Service Note	N0004001
	2000-11

**Subject: IMPORTANT SAFETY RECALL NOTICE**

**Models 580-Series Walk Behind Mowers**

**Replacement  
Blade Adapter  
# 606 00 02-85**

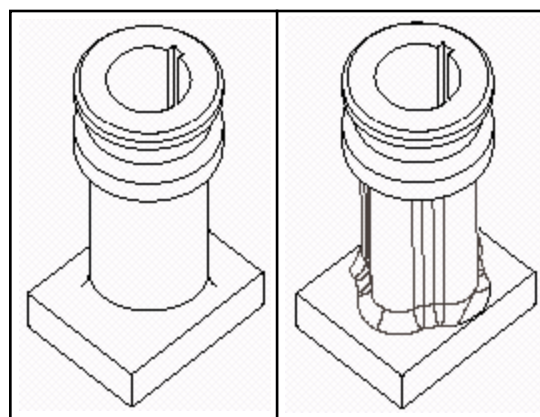
Recently Husqvarna has received reports of blade adapters breaking in a number of the lawnmowers listed above. If the adapter is not replaced promptly, a broken piece of the adapter could fly out from under the mower deck, causing a potential risk of personal injury. Continued use of the mower after adapter breakage could eventually result in detachment of the blade, further damage to the mower and potential risk of personal injury.

A new blade adapter kit # 606 00 02-85 has been produced to replace the existing blade adapter. The new adapter kit incorporates a heavier adapter and two keys for the crankshaft.

Stop sale of the units until the new # 606 00 02-85 has been installed. Contact customers of the above listed walk behind lawnmowers and arrange to have the # 606 00 02-85 installed.
